Memorandum

To	Michael Czarnecki		
Copy to	[REDACTED]		
From	[REDACTED]	Tel	(07) 3316 3000
Subject	Webber Esplanade revetment wall	Job no.	[REDACTED]

COOK SHIRE COUNCIL
WEBBER ESPLANADE
REVTMENT WALL AS-BUILT
DESIGN CHECK - SHEET 1 OF 2

approved (PD) **SK001**

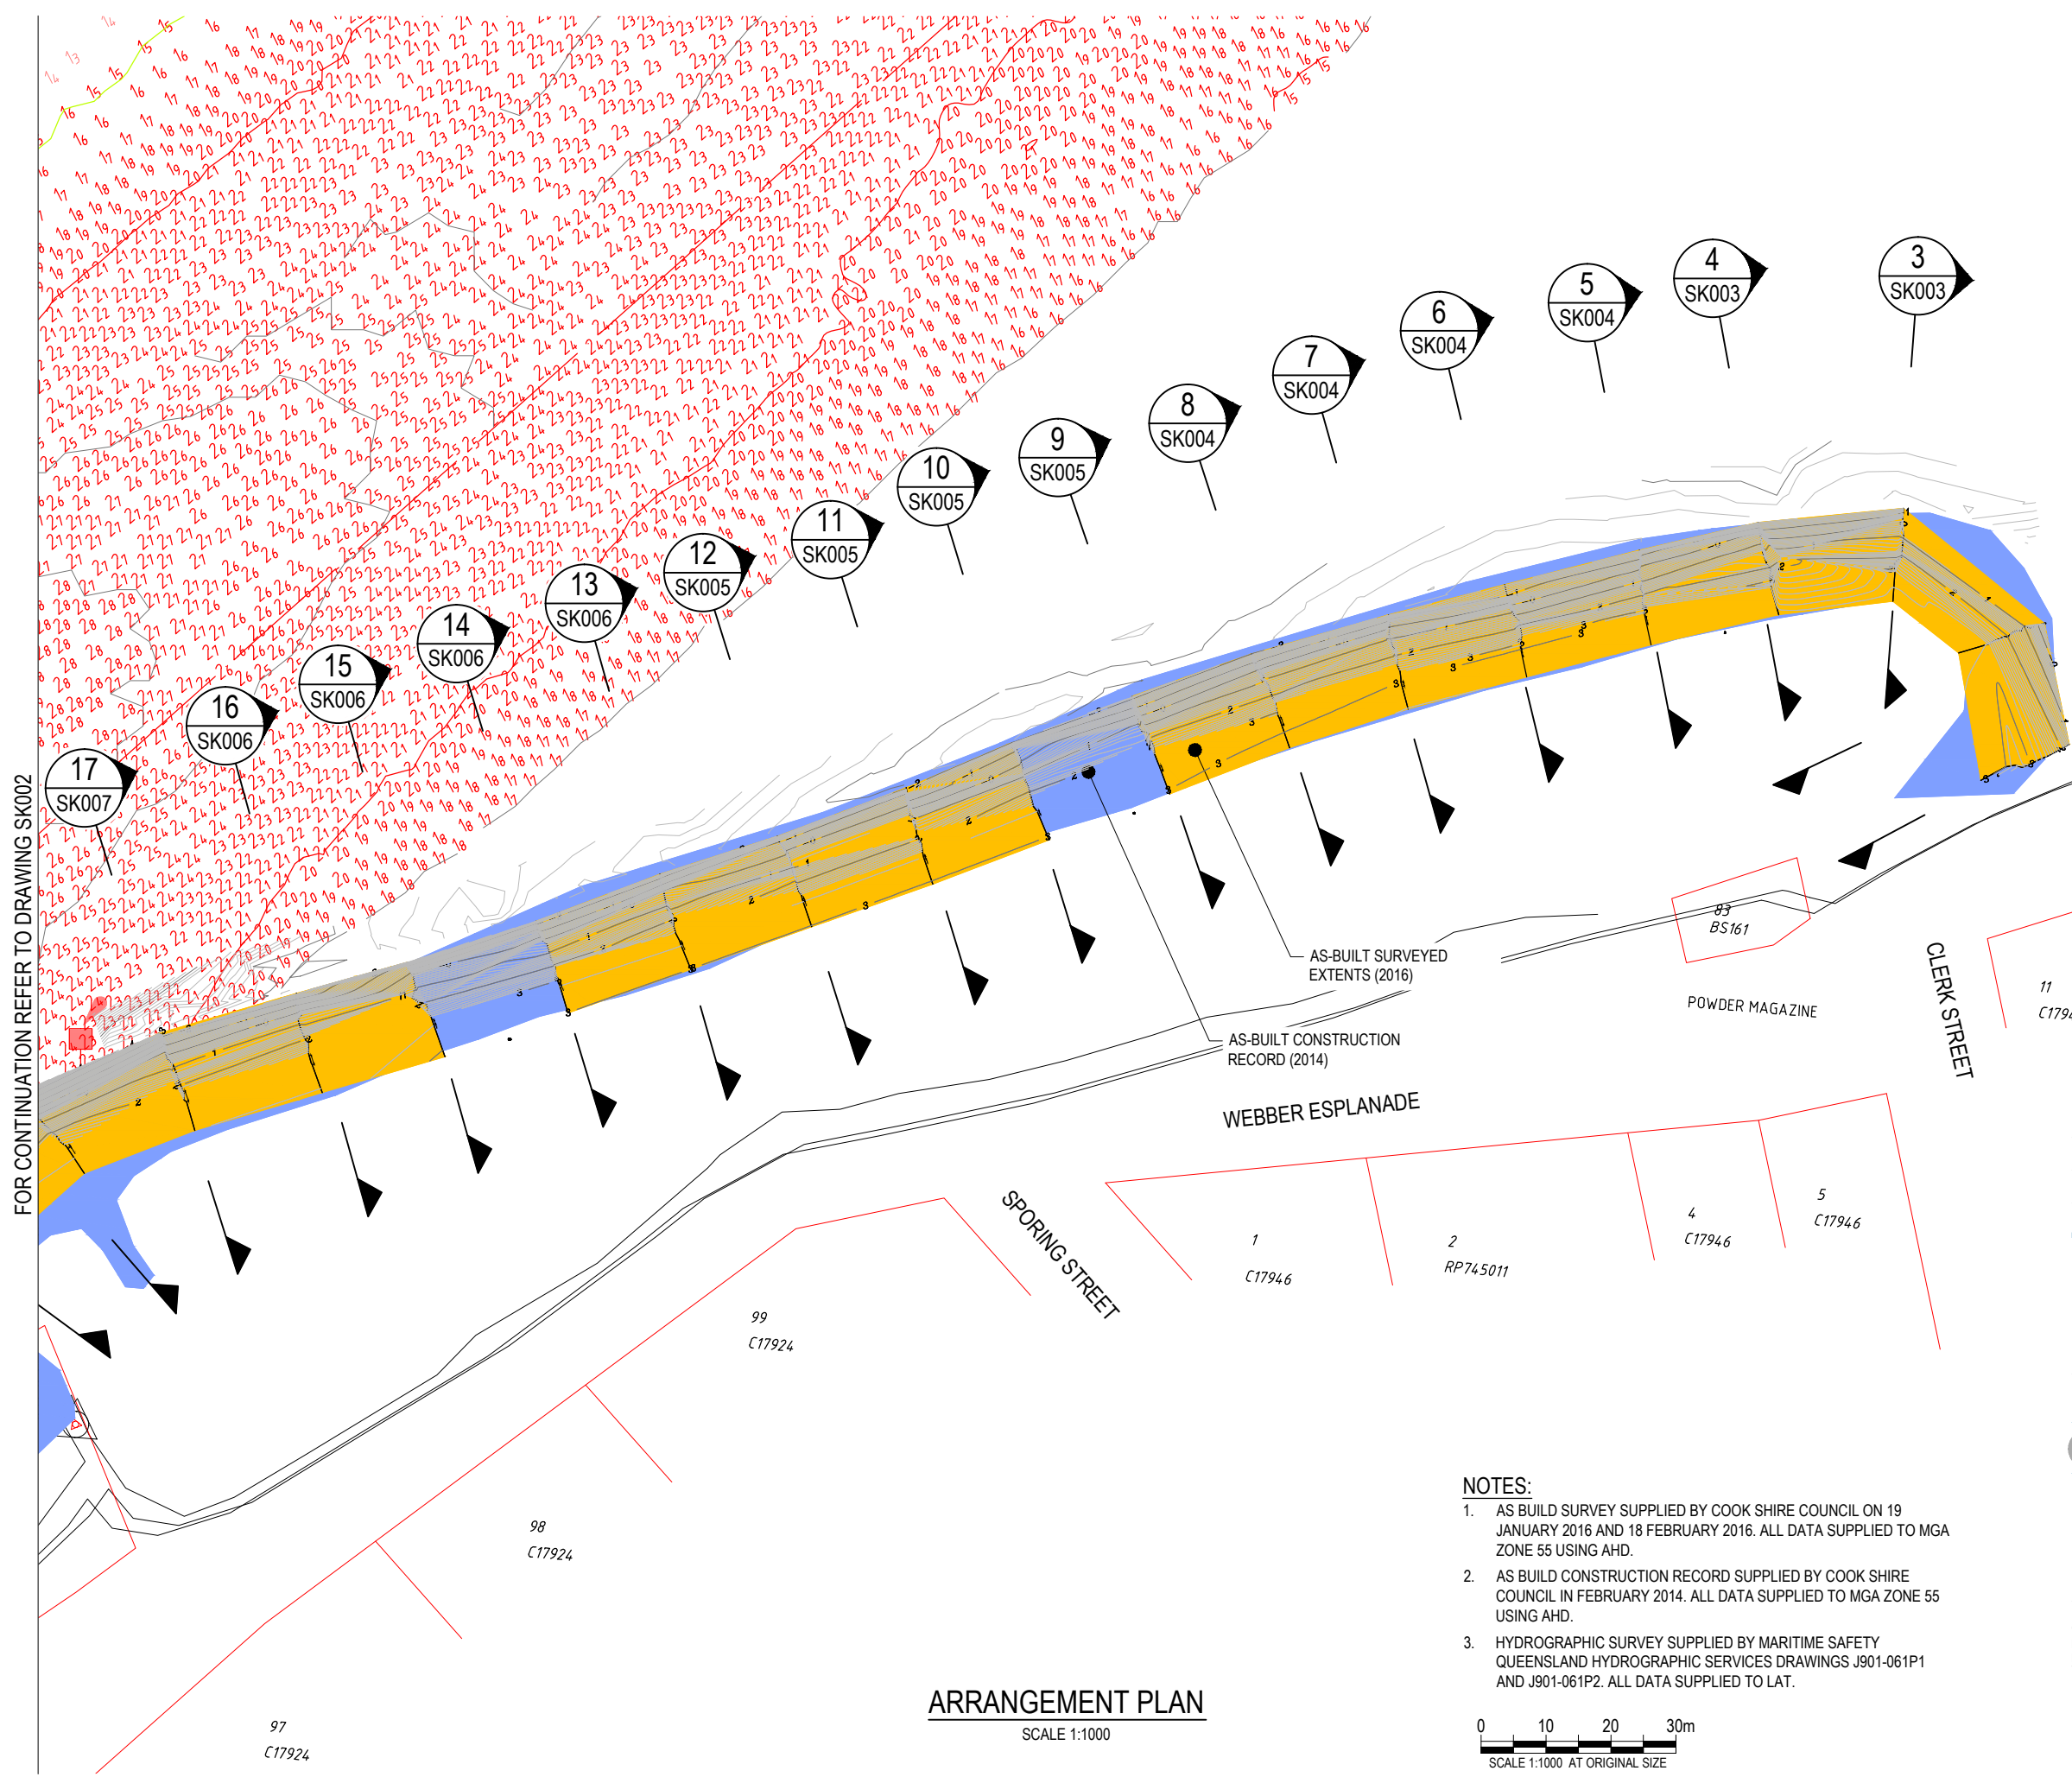
Comparison of survey undertaken on 19 January 2016 by Cook Shire Council against drawings CSC-C001, CSC-C002 and CSC-C003 has been undertaken. Refer to attachments 41-29566 SK001 to SK008. The following comments are provided on the survey comparison;

- The constructed slope is somewhat variable, with sections slopes 1, 2, 3, 4, 5, 6, 7, 8, 9, 10, 11, 12, 13, 14, 15, 17, 18, 19, 21 and 24 generally flatter than the design slope of 1 vertical to 2 horizontal.
- Section 20, 22, 23 have a steeper slope than the design slope of 1 vertical to 2 horizontal.
- For the majority of sections, the rock toe is not clearly distinguishable compared to the design profile.
- It is noted that complete survey coverage over the complete design profile, has not been provided in sections 22, 23 and 24.
- Survey of the seabed has not been provided. To aid further investigation, survey of the seabed is recommended.

In the majority of section comparisons, the construction slope exceeds (flatter) than the design slope of 1 vertical to 2 horizontal.

COOK SHIRE COUNCIL
WEBBER ESPLANADE
REVTMENT WALL AS-BUILT
SECTION REVIEW - SHEET 1 OF 6

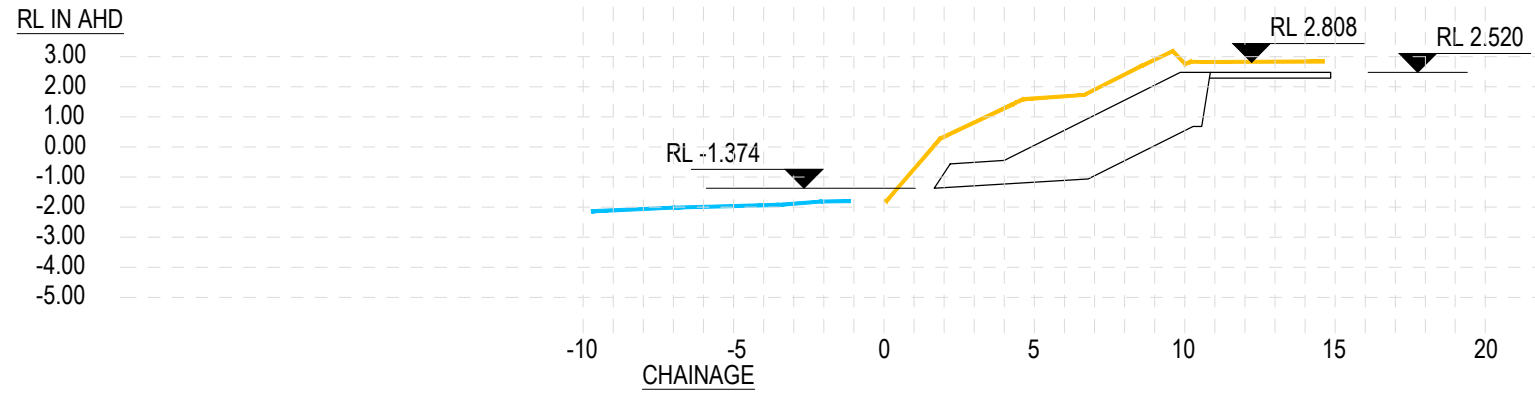
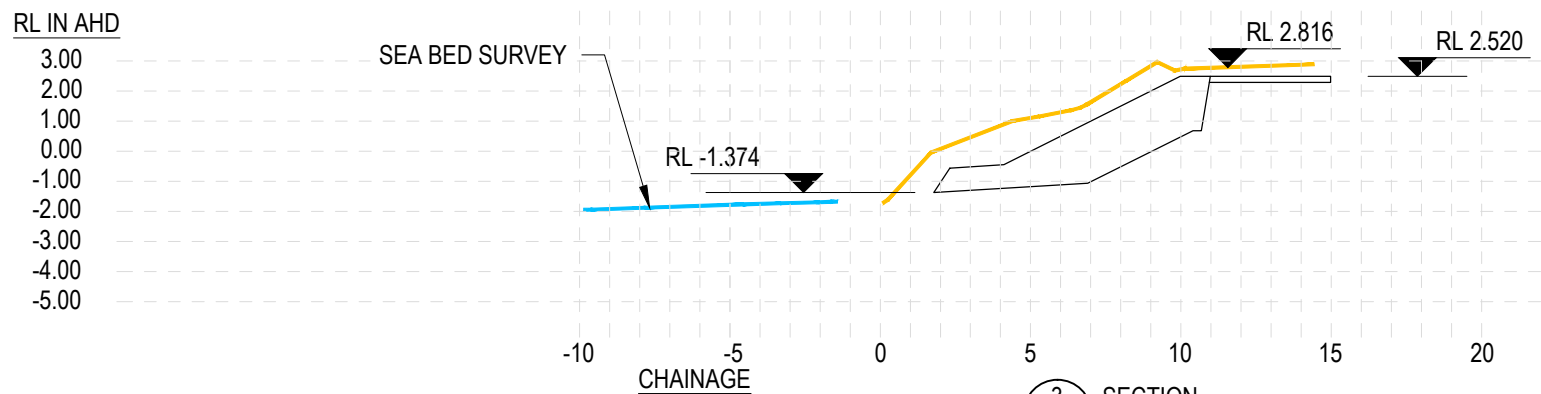
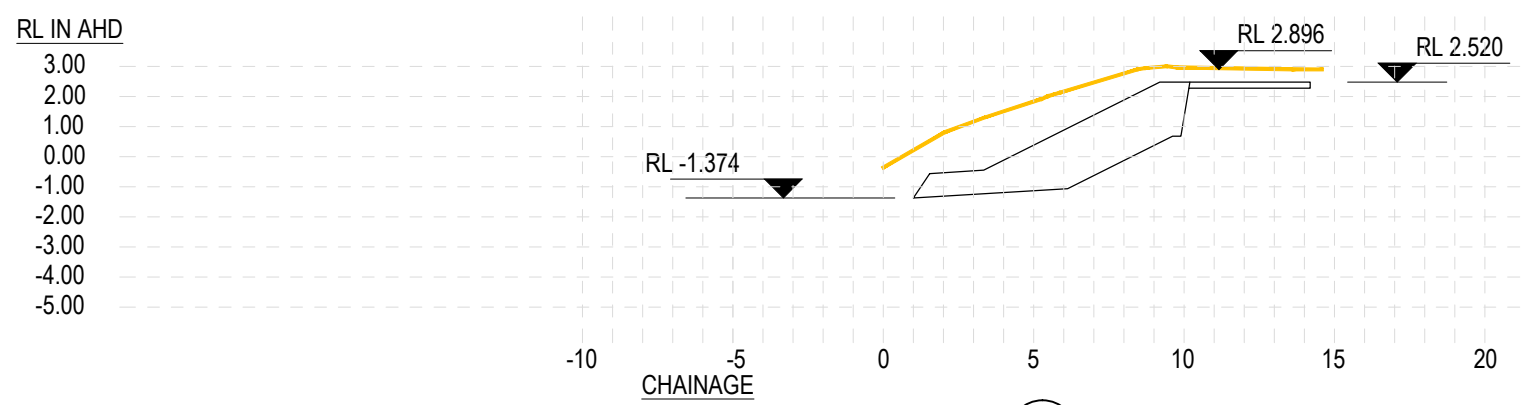
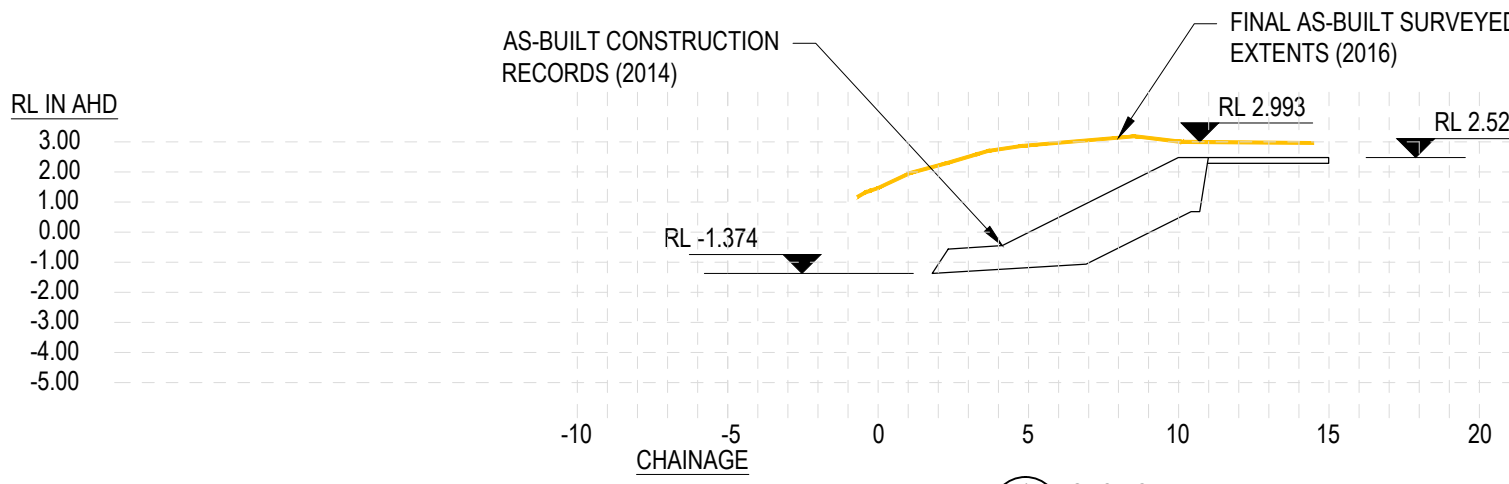
The 'as-constructed' survey shows that the crest level, for most sections in attached 41-29566 SK-001 to SK-008, has generally been constructed above the design level of +2.52 m AHD. Sections 21 through to 23 show a finish level slightly below the design level of +2.52 m AHD.
